## ERRATA LIST

# Apollo2 System on Chip

Ultra-Low Power Apollo2 (AMAPH1KK-xxx) SoC Family  
A-SOCAP2-ELGA01EN v7.0

Figure 3-1: Software Workaround Write Timing

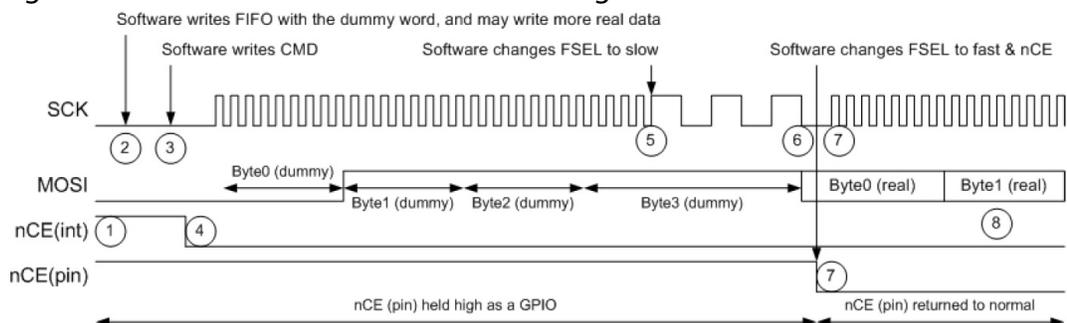
Refer to the timing sequence in Figure 3-1 for references to the occurrence of each of the following steps.

1. The nCE pin is initially configured as a GPIO and held high.
2. The FIFO is loaded with a dummy 32-bit word, which will be ignored by the slave device because nCE will not be asserted when it is transmitted. The dummy word will have all zeros in the first byte, so that the hardware issue, the erroneous load of a bit value of 0 instead of a 1, does not affect it. In the remaining dummy bytes, all bits will be the opposite polarity of the high order bit of the first real transfer byte (the first byte of the 2nd 32-bit word written to the FIFO). In this first scenario, the high order bit of Byte0 (real) is a 1, so the dummy bytes are all zero.

3. A write to the CMD register to perform a Raw Write is made, with the desired transfer length + 4 bytes. Interrupts are disabled prior to the CMD write.

4. The internal nCE signal goes low, but the nCE pin is held high as a GPIO.
5. The HAL code waits until the transfer is in the middle of the 4th byte. At that point the IOM frequency is divided by the smallest power of 2 which reduces it below 1 MHz. This allows the HAL to reliably change the nCE pin back to normal mode.

6. SW waits until it sees a transition on the MOSI pin, which<sup>1</sup> can be observed as a GPIO even in MOSI mode. This indicates that the falling edge of the 32nd clock has occurred.

7. When the edge is detected, the nCE pin is switched back to the normal nCE function and the clock frequency is returned to the original requested frequency. Interrupts are enabled at this point.

Figure 3-2: Software Workaround Write Timing - Alternate First-byte Scenario

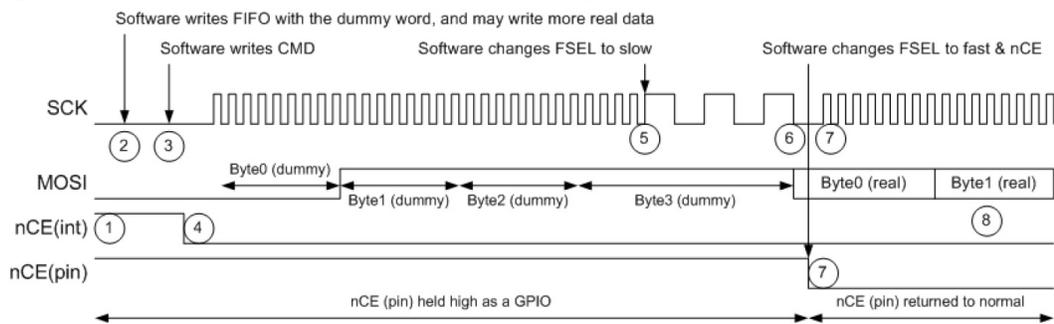
The scenario in Figure 3-2 below presents the alternate case from the above (see step 2) where the high order bit of Byte0 (real) is a zero. In this case Byte0 (dummy) is all zeros, but the other dummy bytes are all ones. This produces an edge on MOSI at the same point (6) as the above scenario.

Figure 3-3: Software Workaround Read Timing

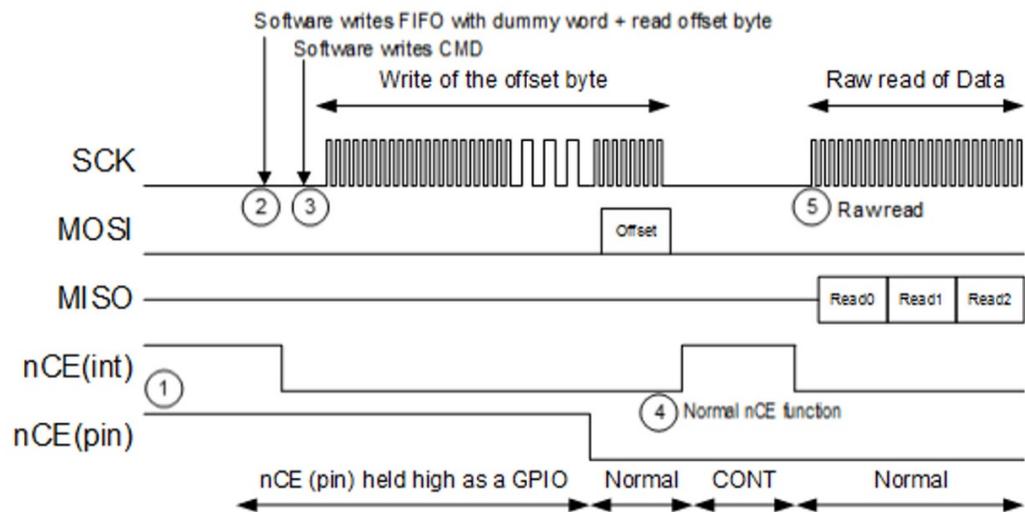
SPI read operation in the IOM4 workaround is implemented primarily in two separate operations which are combined into a single transfer using the CONT function. Refer to the timing sequence in Figure 3-3 on page 14 for references to the occurrence of each of the following steps.

1. The nCE pin is initially configured as a GPIO and held high.
2. The initial operation is a write of 5 bytes, with the first four being dummy bytes as described above in the HAL Write operation and the 5th byte being the read offset byte. The CONT bit is set for this operation, which holds nCE low after it is configured as a normal function in step 4.
3. A write to the CMD register to perform a Raw Write is made, with the desired transfer length + 4 bytes. Interrupts are disabled prior to the CMD write.
4. nCE is configured as normal function and not as a GPIO at the end of the write operation.
5. The second operation is a raw read with the length from the desired read operation, and nCE is handled normally. The CONT bit is not set for this operation.

Figure 3-4: Valid I<sup>2</sup>S Timing

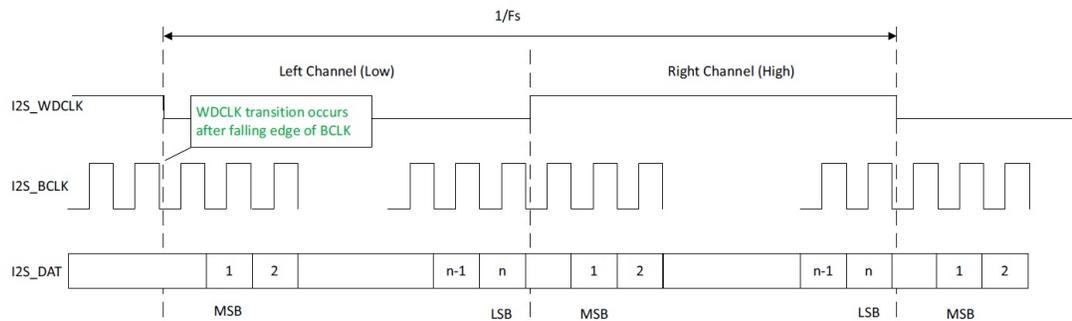
The timing diagram in Figure 3-4 shows the timing relationship among the BCLK, WDCLK and I<sup>2</sup>S\_DATA signals as seen and required by the host controller. Here you can see that the I<sup>2</sup>S\_WDCLK edge transition occurs an adequate time after the falling edge of I<sup>2</sup>S\_BCLK for it to be sampled and observed.

Figure 3-5: I<sup>2</sup>S Timing Due to Propagation Delays on BCLK input

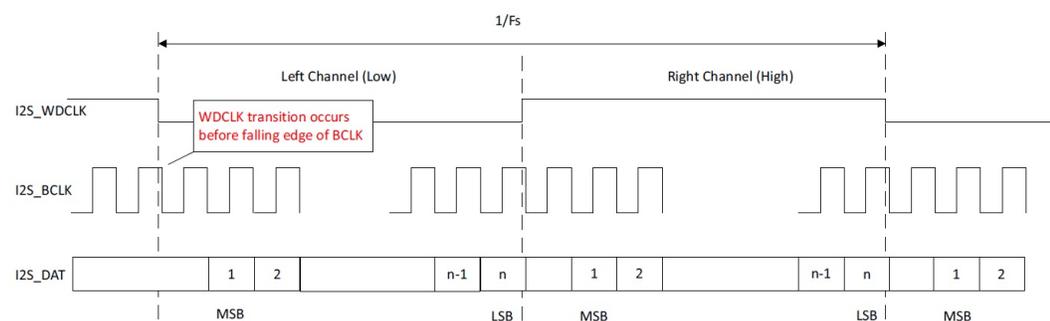
The issue for this erratum is that WDCLK is sampled on the falling edge of BCLK instead of on the rising edge. At least 4 ns of hold time is required on WDCLK after the falling edge of BCLK, and if WDCLK transitions too close to the falling edge of BCLK, the WDCLK edge is missed completely. Internally, BCLK encounters some propagation delays which cause the WDCLK transition to occur too close to the falling edge of BCLK. The solution is to delay the transitions of WDCLK so they do not occur near the falling edge of BCLK, and the delay can be anything from 4 to 60 ns.

The timing diagram of Figure 3-5 shows the relative timing of the BCLK and WDCLK at the input of the I<sup>2</sup>S module internal to the SoC. This shows how propagation delays in the BCLK line causes the transition of WDCLK to occur too close to, or just prior to, a falling (sampling) edge of BCLK. This prevents the slave from seeing the WDCLK transitions and thus results in no transmission of data by the slave.

Figure 3-6: Interface Circuit for BCLK Propagation Delay Workaround

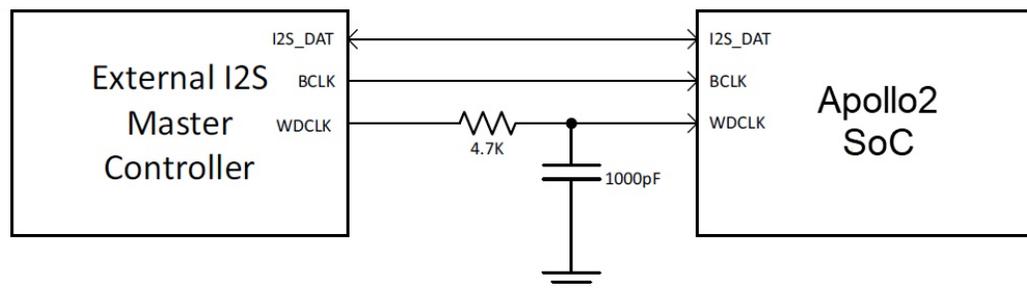
The only known workaround to address this issue is a hardware implementation to delay the WDCLK input to the SoC's I<sup>2</sup>S module to offset the propagation delays on the BCLK line. A delay of only 4 ns is required on the WDCLK to eliminate this race condition, and can be accomplished by adding an R-C network on the WDCLK input to the SoC. This R-C lengthens the rise and fall times of the WDCLK clock edges long enough to ensure that the falling edge of BCLK occurs before a WDCLK transition. Suitable resistor and capacitor values are as follows:

- R = 4.7 kΩ
- C = 1000 pF

The required circuit is as shown in Figure 3-6.

Implementation of this circuit causes an adequate delay on the WDCLK line which results in the proper timing relationship as seen in Figure 3-4 on page 18. The I2S\_WDCLK transition correctly occurs at least 4 ns after a falling edge of I2S\_BCLK which triggers the initiation of left and right channel data transmissions.

Figure 3-7: Shortened High Phase of SCL Due to Unrecognized Clock Stretch by Slave

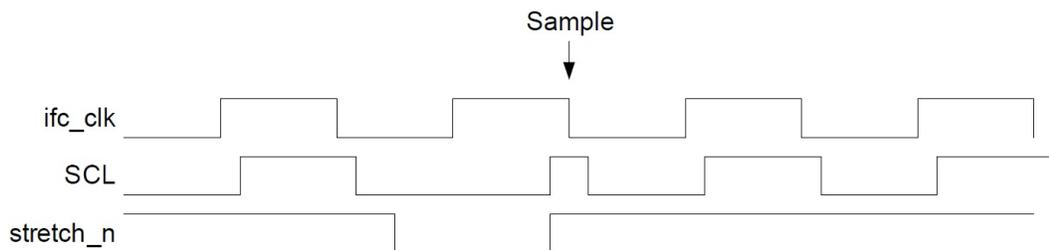
The problem occurs because the slave device releases the pull-down of the internal stretch\_n signal before the next falling edge of the clock. Since the IOM has already released SCL, it immediately goes high. However, since the SCL is sampled (as high) on the falling edge of the clock as shown in Figure 3-7, the stretch is not recognized and SCL is pulled low for the next cycle. This results in a very short high pulse on SCL (a “glitch”) which can corrupt the operation within the slave device.

Note that if the stretch lasts through the next falling edge of the clock, the stretch would be recognized and SCL would not be pulled low at that point. Thus the failure only occurs if three factors are evident, whereby the slave device:

Figure 3-8: Occurrence of Sample with a Faster Clock

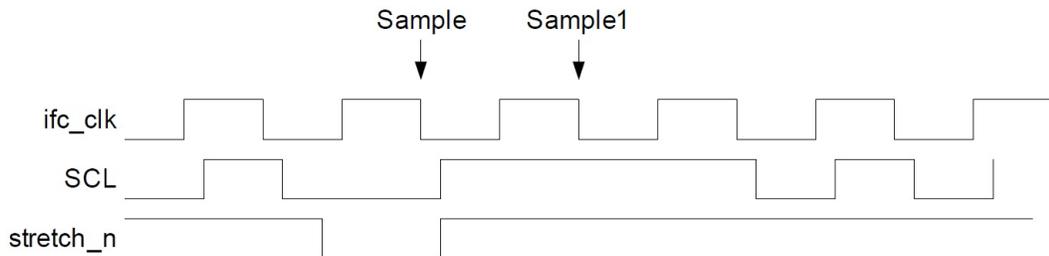
The first solution involves running the clock faster which, for a given stretch time, guarantees that the stretch time is longer than the clock cycle. This is shown in Figure 8 below. Since SCL is low at the Sample point, the stretch is detected and SCL is not pulled low then. Instead, the IOM waits until SCL is sampled high (at Sample1 in Figure 3-8) and then SCL is released one cycle later.

Figure 3-9: Occurrence of Sample with a Slower Clock

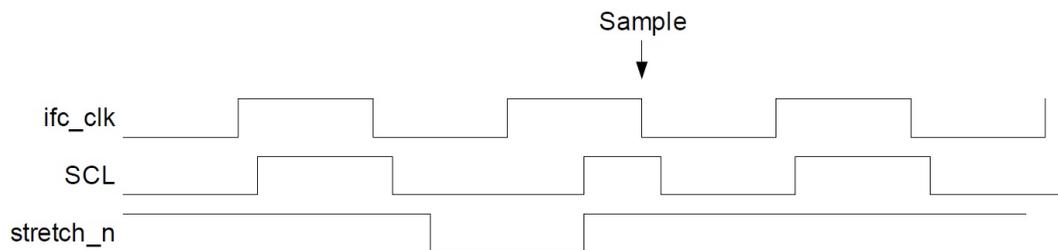
The second solution is to run the clock slower so that the short SCL pulse will still be long enough, as shown in Figure 3-9 on page 30 below. The minimum required high time for the SCL in Fast Mode is 600 ns, so if the stretch time is 2.4  $\mu$ s the clock frequency would have to be  $1/(3.0 \mu\text{s}) = 333 \text{ kHz}$ .

The challenge with this approach is that if the stretch time is longer than 2.4  $\mu$ s, the glitch would be shorter and could still fail.
